**SECTION 00 90 03
BIDDING AND CONTRACT REQUIREMENTS
ADDENDUM NUMBER 3**

Re: ADDENDUM NUMBER (3) TO THE BIDDING DOCUMENTS FOR

**McHenry County College
University Center at MCC**
Architect's Project Number: 22-050

SHEET NUMBER:
E3.00

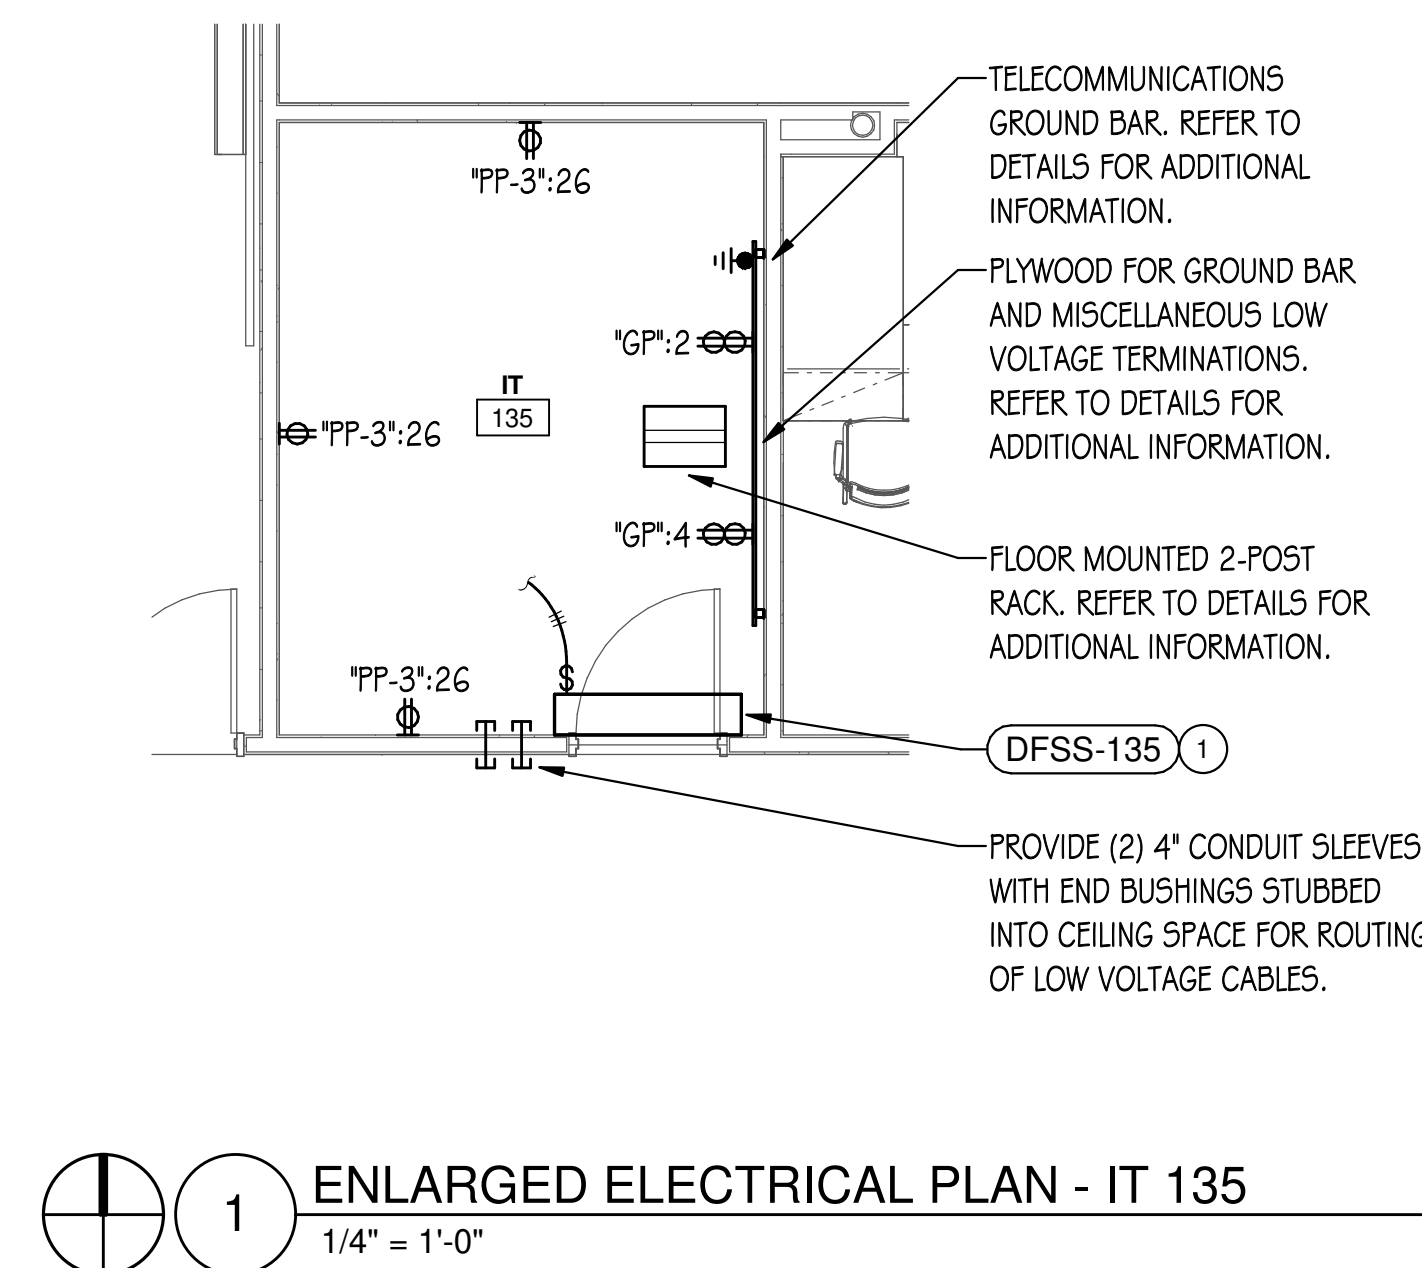
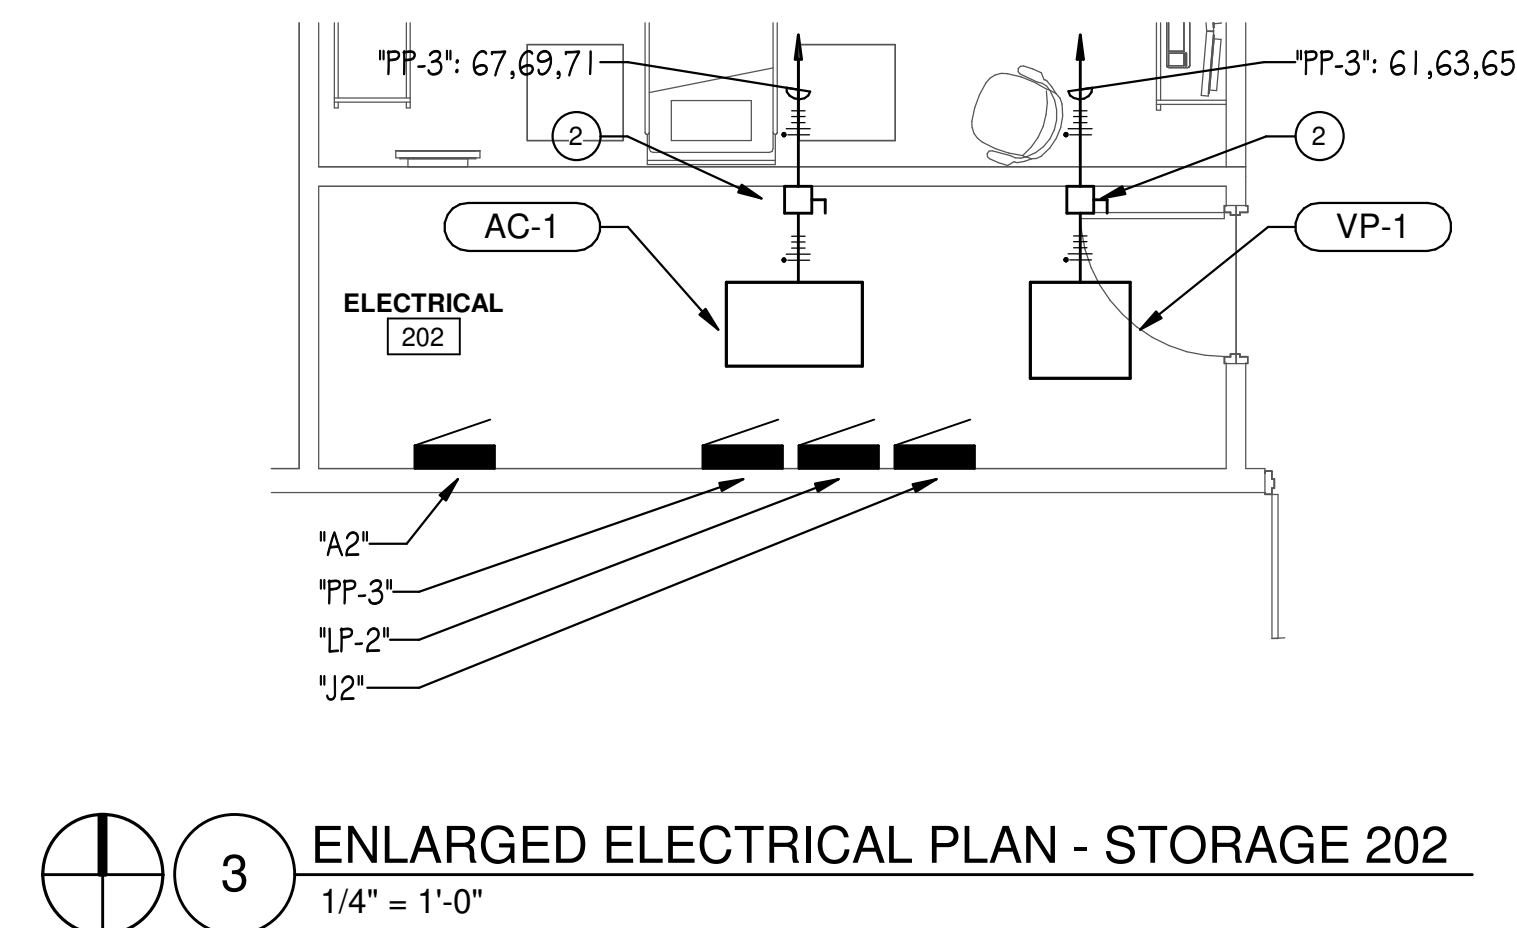
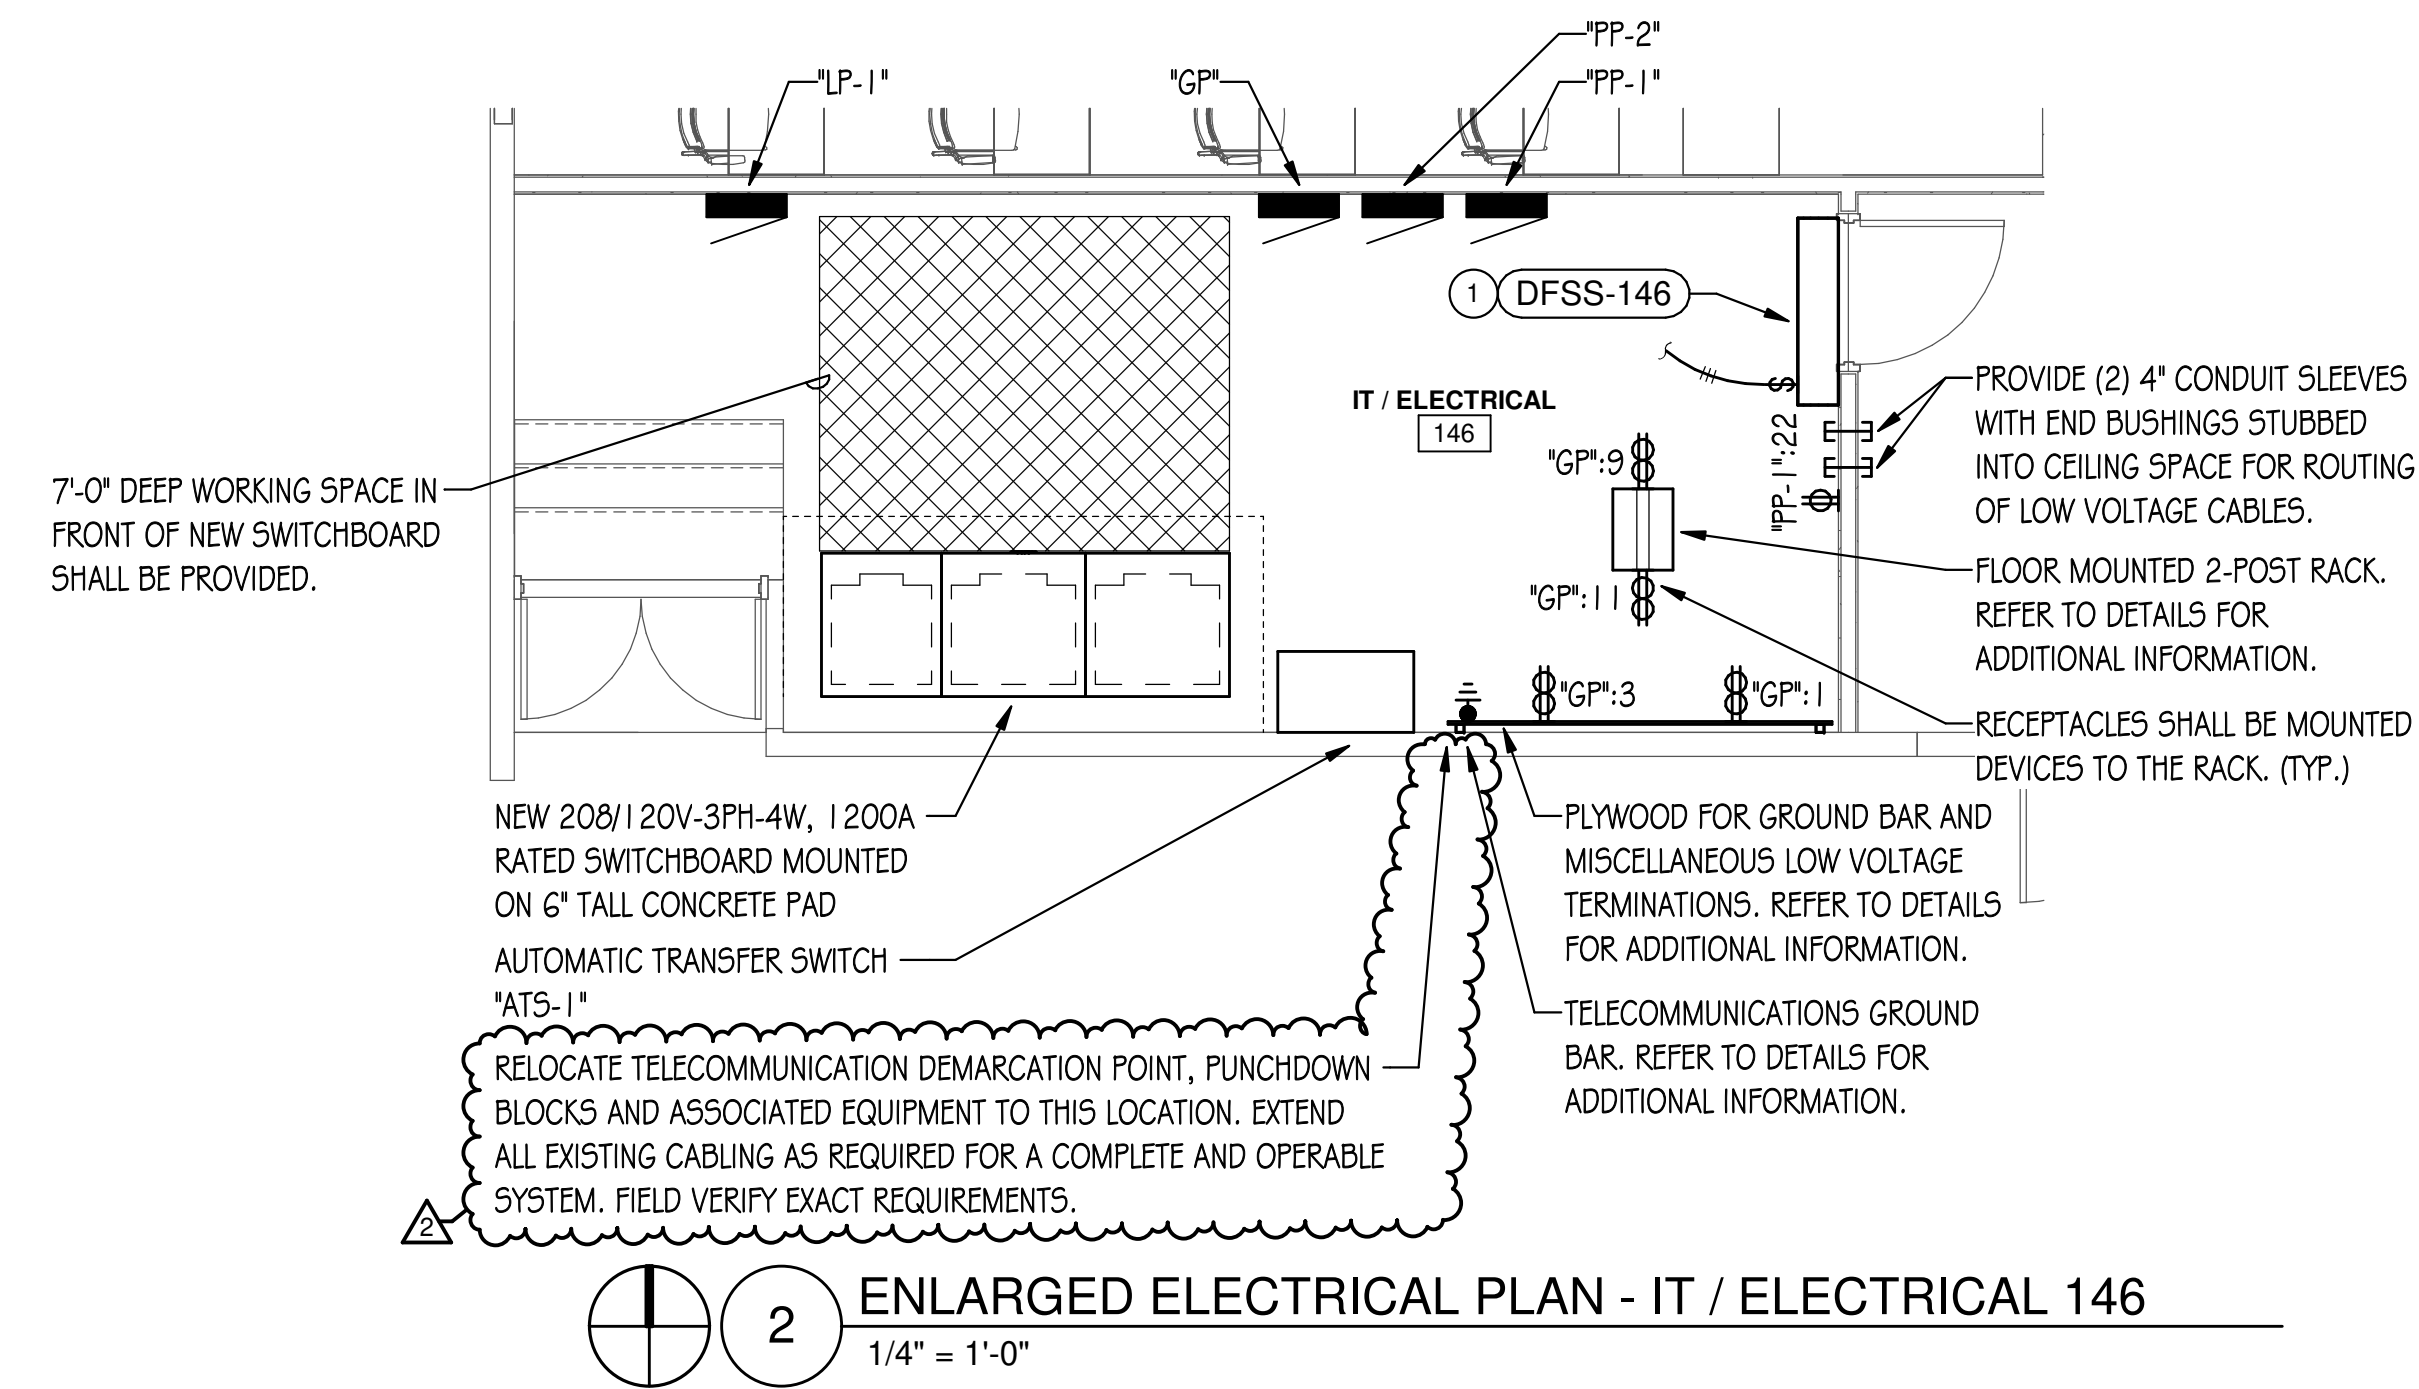
- C. **ADD** switch to control existing fiber-optic lighting in Classroom 102.
4. E3.00
 - A. **ADD** note to show new location of telecommunication equipment in IT / Electrical 146.

ACCESS CONTROL / SECURITY DEVICE DETAIL
 NO SCALE

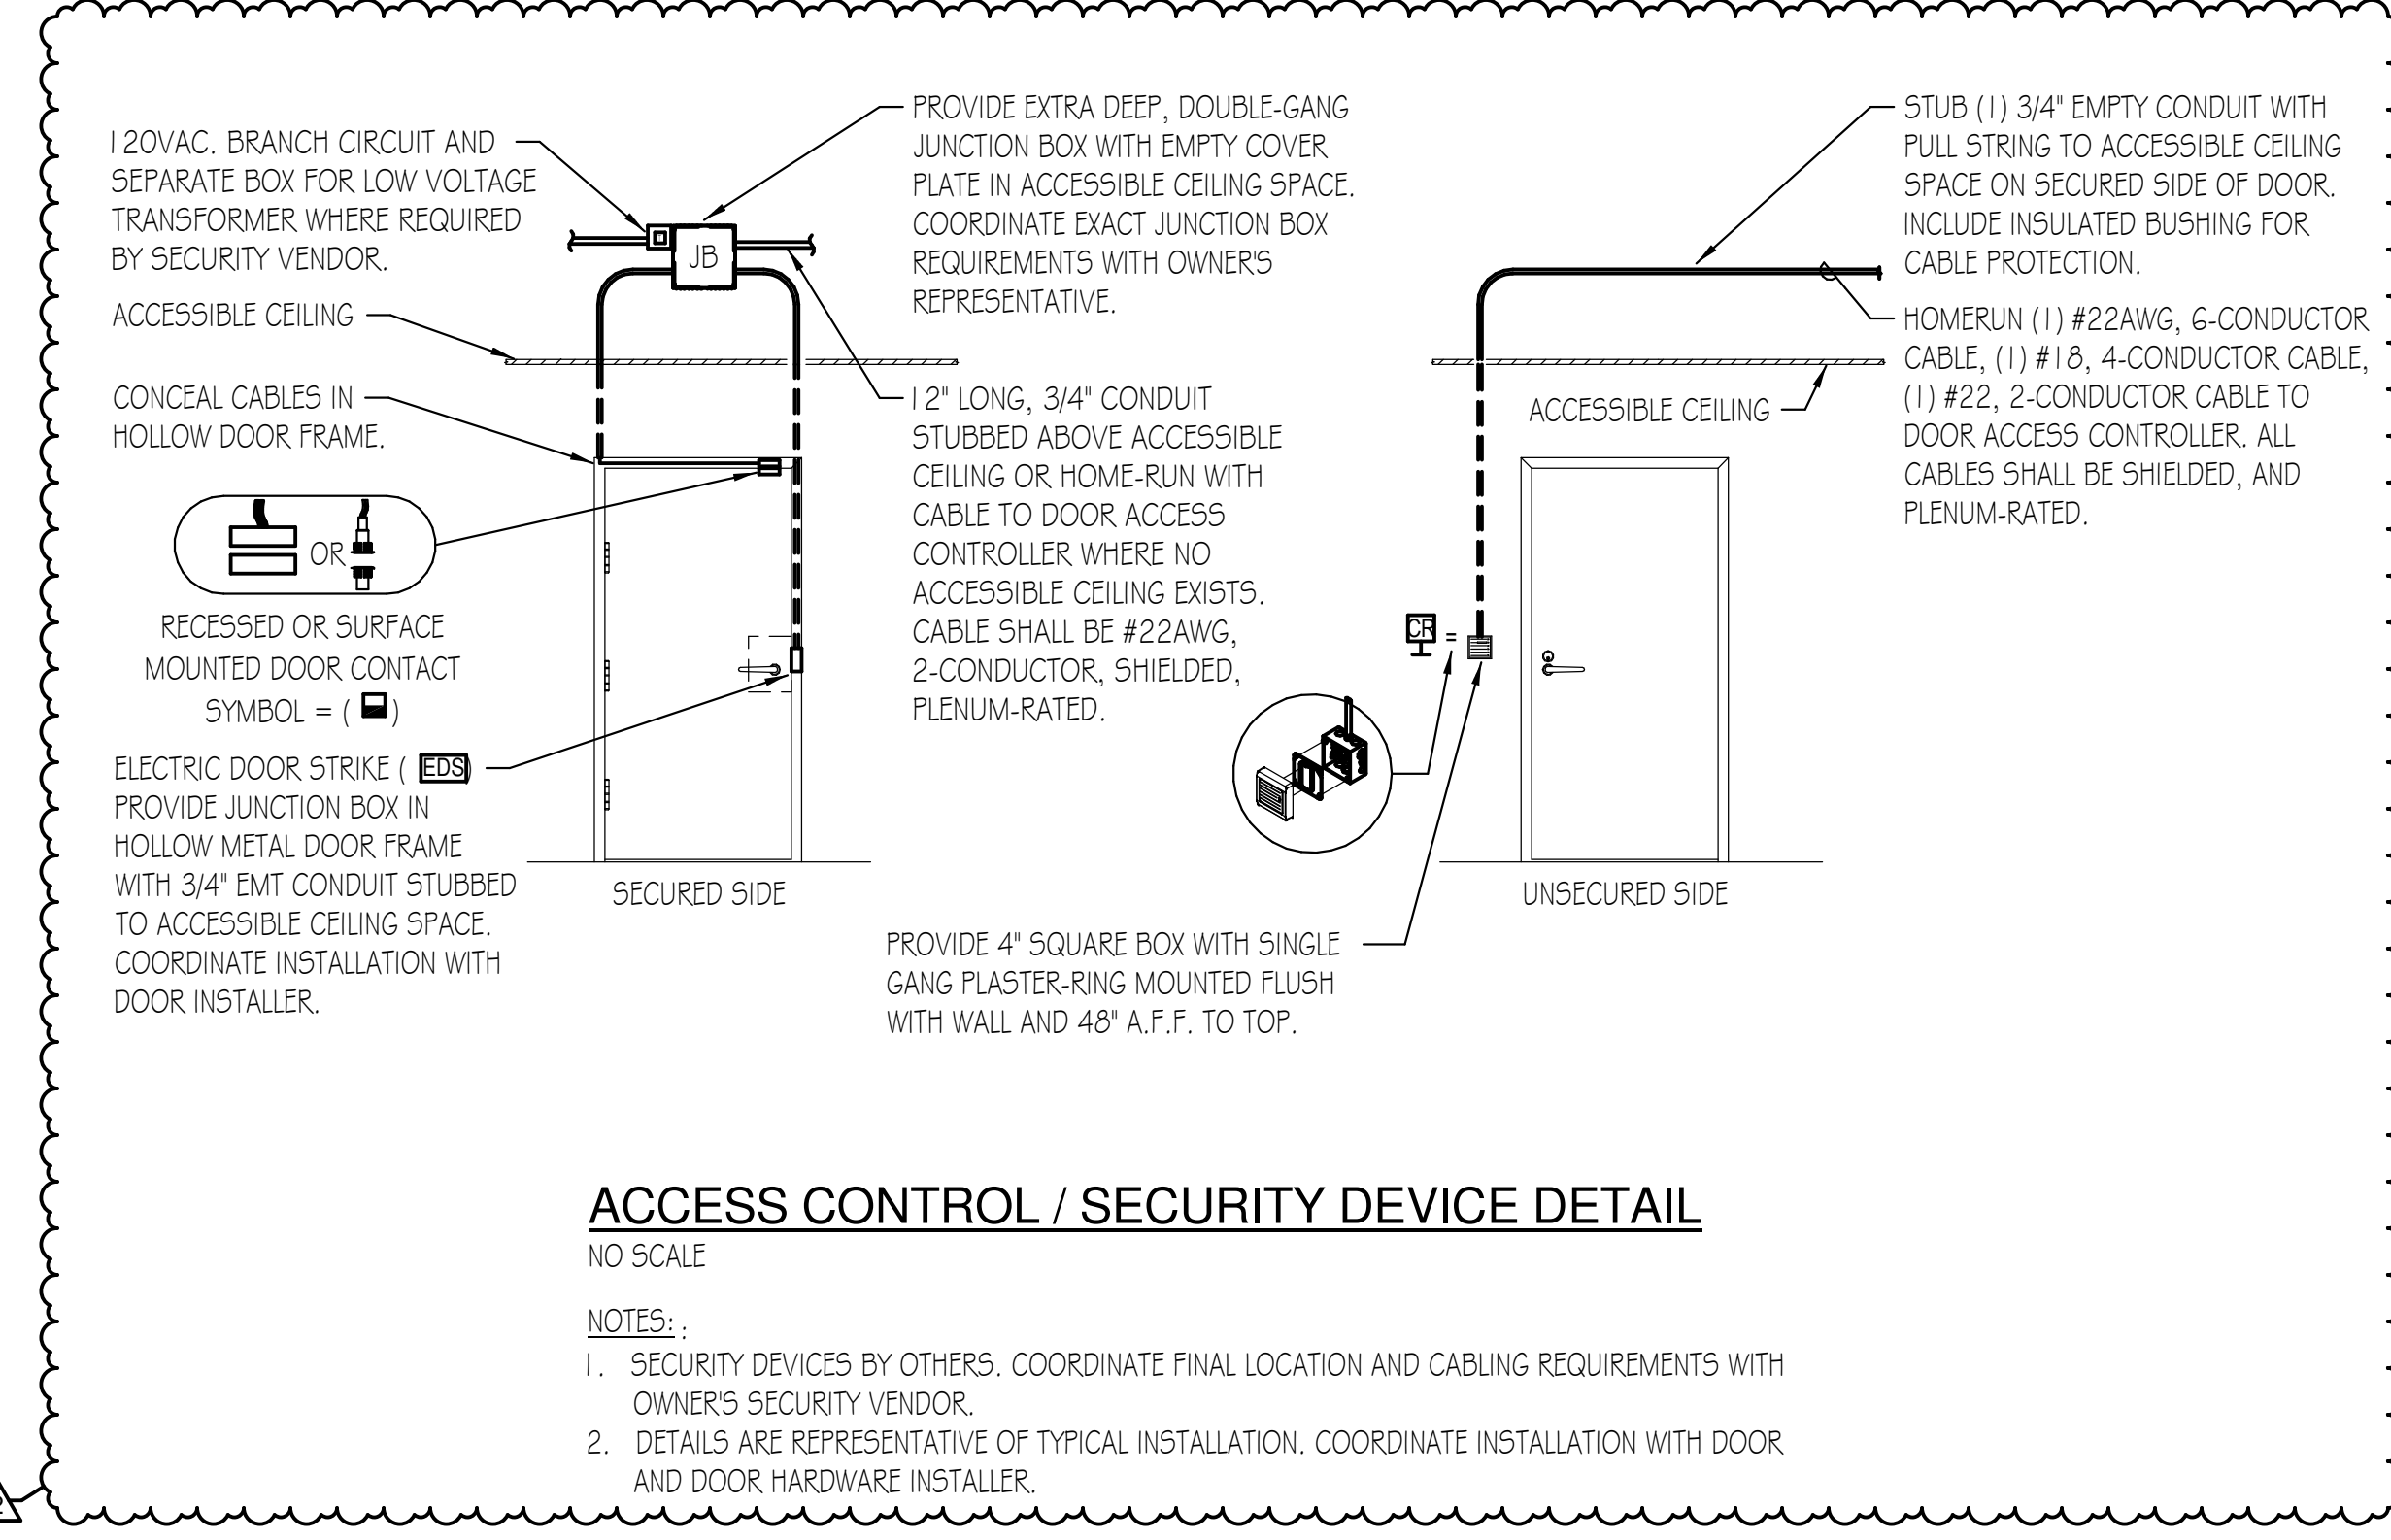
5. E6.00
 - A. **REVISE** luminaire types "F3A" and "F7".
6. E7.20
 - A. **REVISE** 'ACCESS CONTROL / SECURITY DEVICE DETAIL'.
7. E7.30
 - A. **REVISE** 'CLASSROOMS A/V SCHEMATIC DIAGRAM'.
